ARCHITECTURAL REVIEW BOARD REGULAR MEETING AGENDA

September 10, 2026

DATE: September 10, 2026
TO: Architectural Review Board
FROM: Renee Burton, Division Director of Planning
RE: Certificate of Appropriateness application PZ26-00457 filed by Lynn Partners, LLC for exterior renovations at Parcels 25198, 22862, and 22861 (300 Lynn Street, 411 Loyal Street, and 417 Loyal Street).

DATE: September 10, 2026
TO: Architectural Review Board
FROM: Renee Burton, Division Director of Planning
RE: Certificate of Appropriateness application PZ26-00455 filed by Dan Hotel River St LLC for new signage at Parcel 01078 (100 River Street).

Photo 4E: Windows, Section A typical conditions: deteriorated rails and stiles, muntins, and glazing

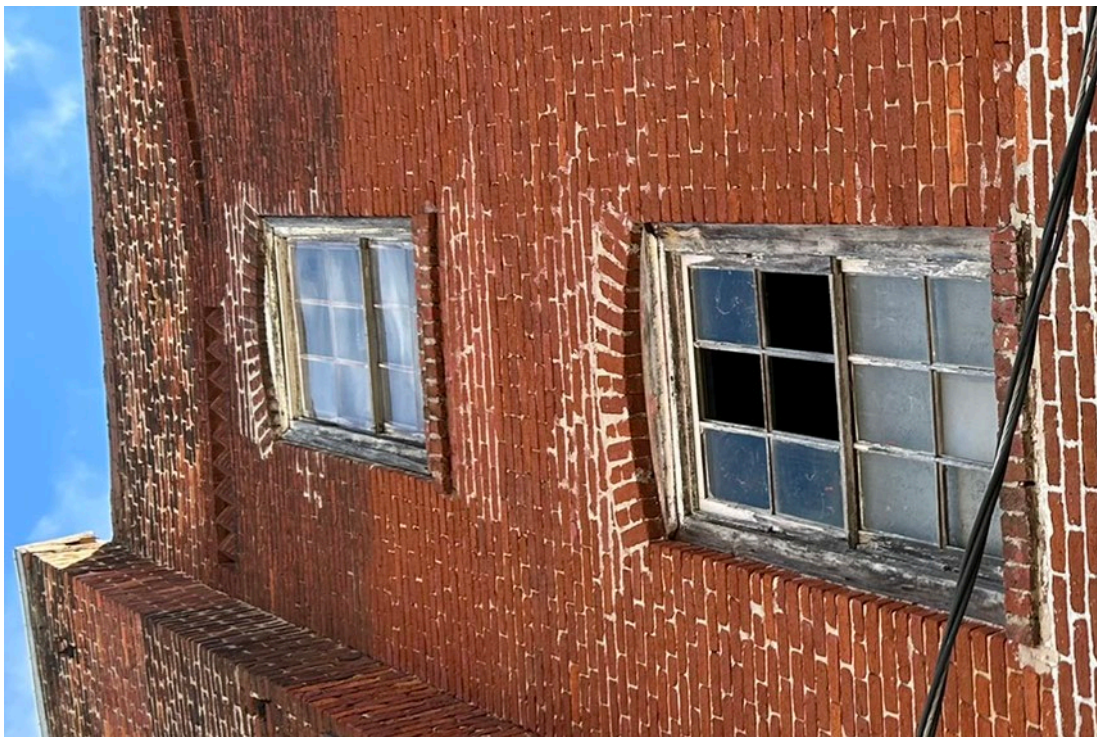
- Remove modern infill at window openings where indicated in the drawings.
- Remove the remaining deteriorated historic wood windows and replace them with new windows based on the size, proportions, profiles, and configurations of the historic units and available photographs.
- Install new 6/1 double-hung aluminum-clad wood windows at historic window openings. Simulated divided lights will include interior and exterior muntins with internal spacer bars to

1
D2.1
1/8" = 1'-0"

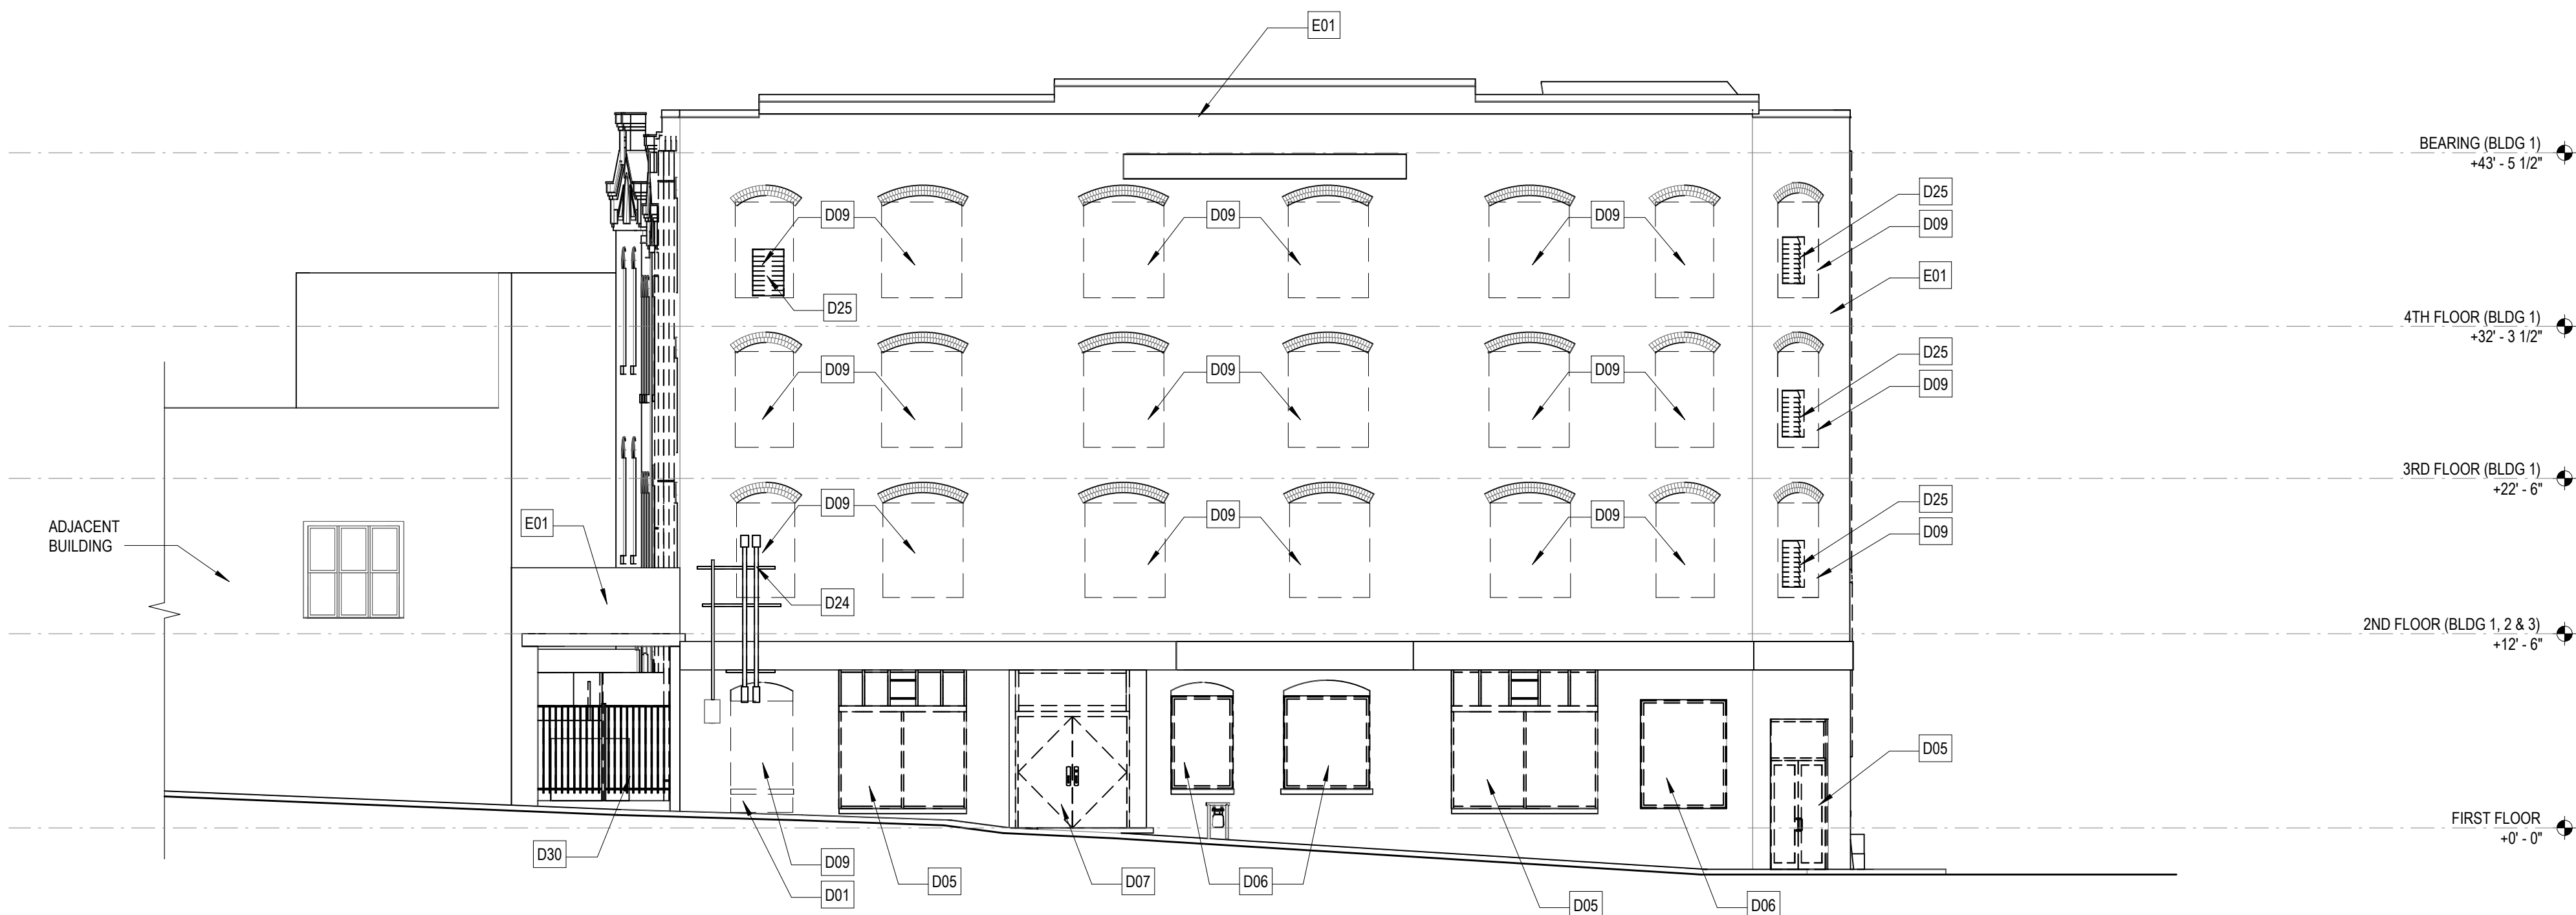
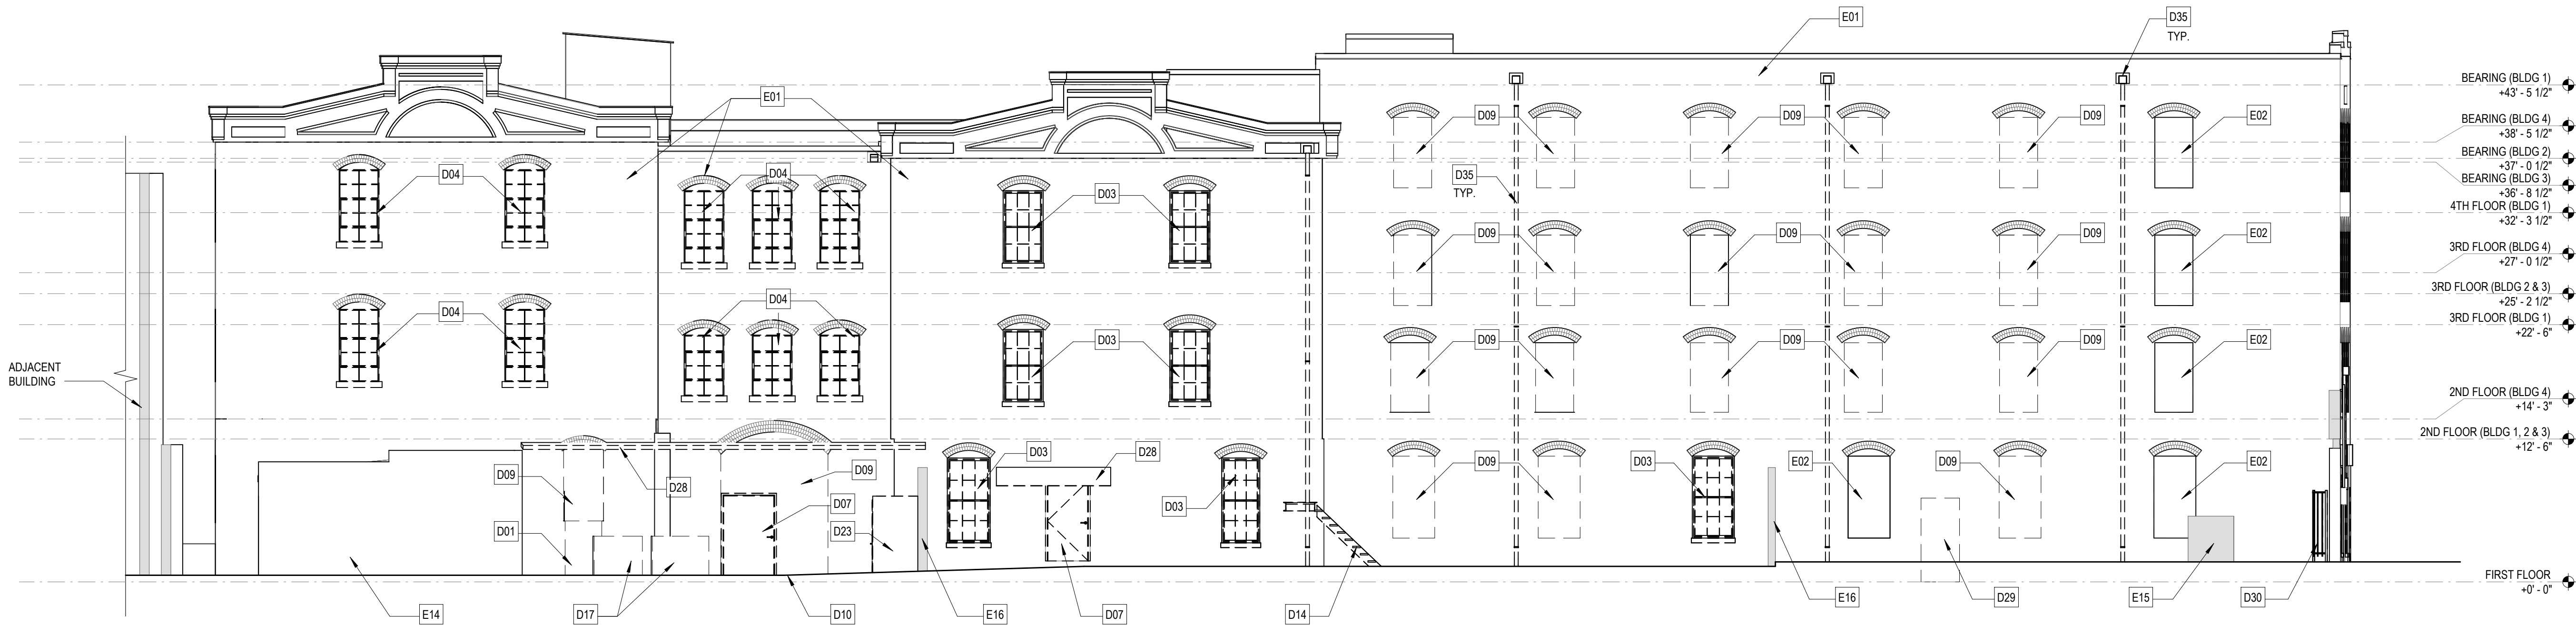
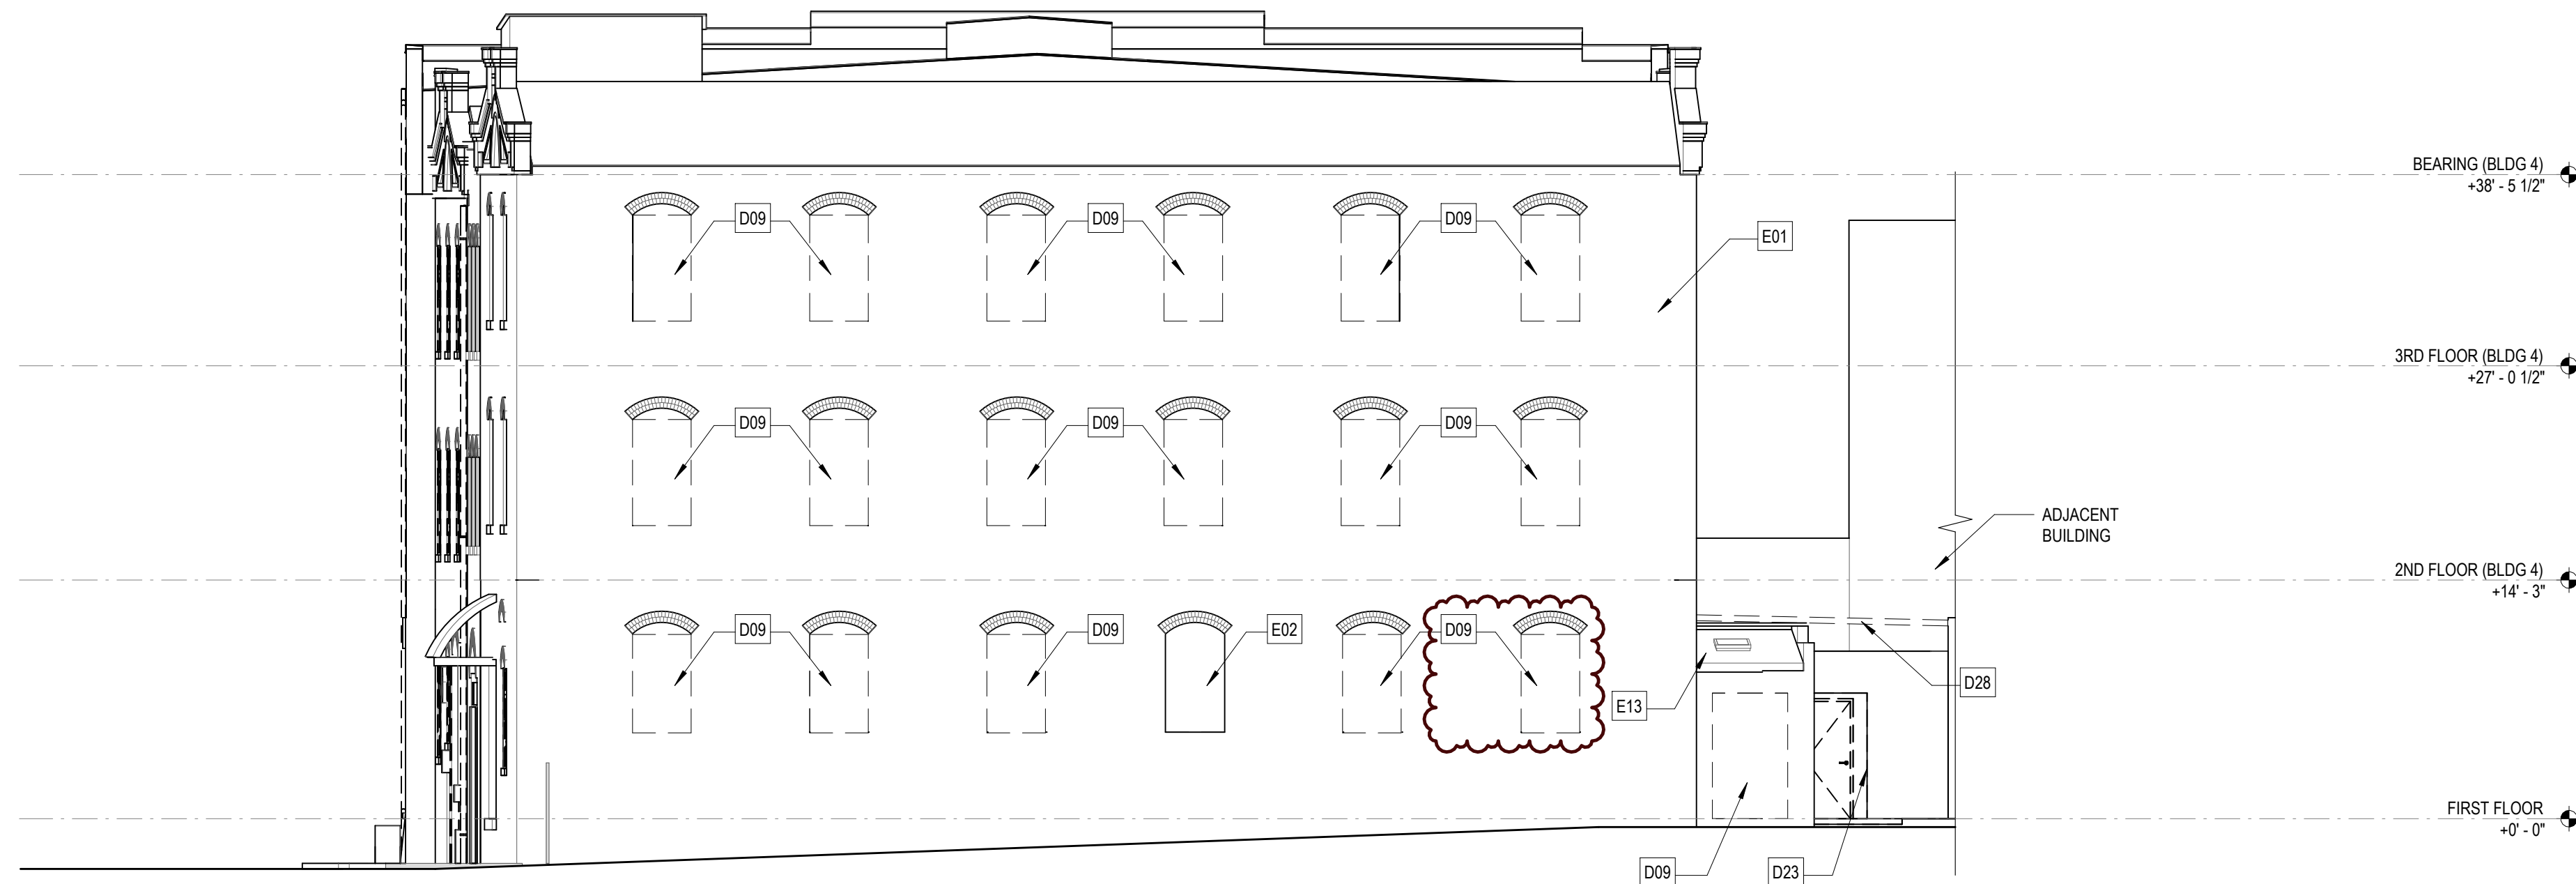
Planning staff recommends the following with regard to Certificate of Appropriateness application PZ26-00457, filed by Lynn Partners, LLC, for exterior renovations at Parcels 25198, 22862, 22861 (300 Lynn Street, 411 Loyal Street, and 417 Loyal Street):

- Avoid painting masonry entirely, and instead, use 100% vapor permeable protection where necessary;
- Replace stucco only in places where historically supported; and
- Obtain required sign permit(s).
